Brightseat Industrial

DSP-22020

STAFF REPORT

SUBJECT: Detailed Site Plan DSP-22020
Type 2 Tree Conservation Plan TCP2-043-2023
Variance to Section 27-471(f)(2)
Brightseat Industrial

Figure 1: Site Plan

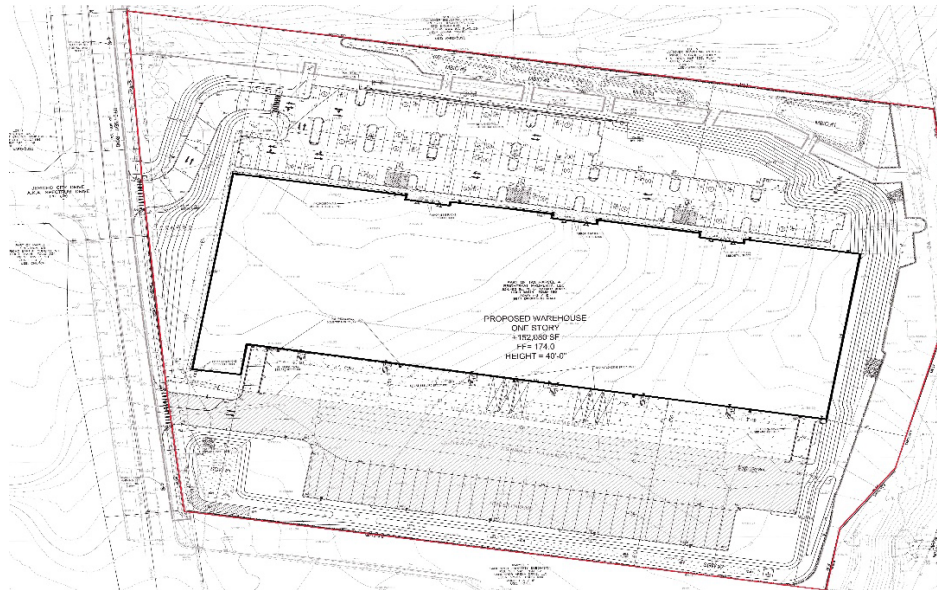
This DSP includes five loading spaces, located on the south side of the proposed building, separated from the proposed parking area for the distribution warehouse, which is to the north of the building. Trash facilities were not shown on the submitted site plan. A condition has been included herein requiring the applicant to show the location of any proposed trash facilities.

1. Prior to certification, the detailed site plan (DSP) shall be revised, or additional information shall be provided, as follows:
 - a. Revise General Note 39 on the cover sheet to list all of the requirements stated in Condition 3 of Certificate of Adequacy ADQ-2022-032.
 - b. Revise General Note 15 on the coversheet to state that a 10-foot-wide public utility easement shall be provided along Brightseat Road, and that a variation from Section 24-122(a) of the prior Subdivision Regulations was approved with Preliminary Plan of Subdivision 4-22046, to omit a public utility easement along the I-95/495 (Capital Beltway).
 - c. Show and label the location of all trash facilities and their associated screening.
 - d. Provide the tree canopy coverage schedule on the landscape plan.

Figure 4: Freestanding Sign – Front Elevation

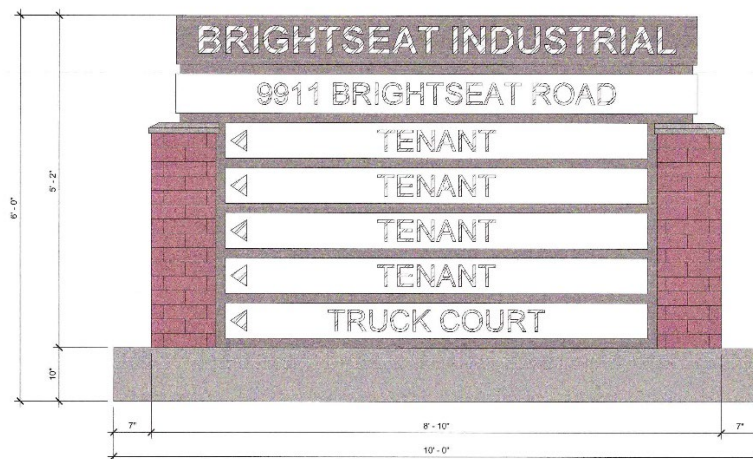
- 1. The setback of the monument sign from the street should be shown on the detailed site plan sheet.
 - 2. If the size of the individual tenants signs is fixed, it should be dimensioned on the monument sign detail.
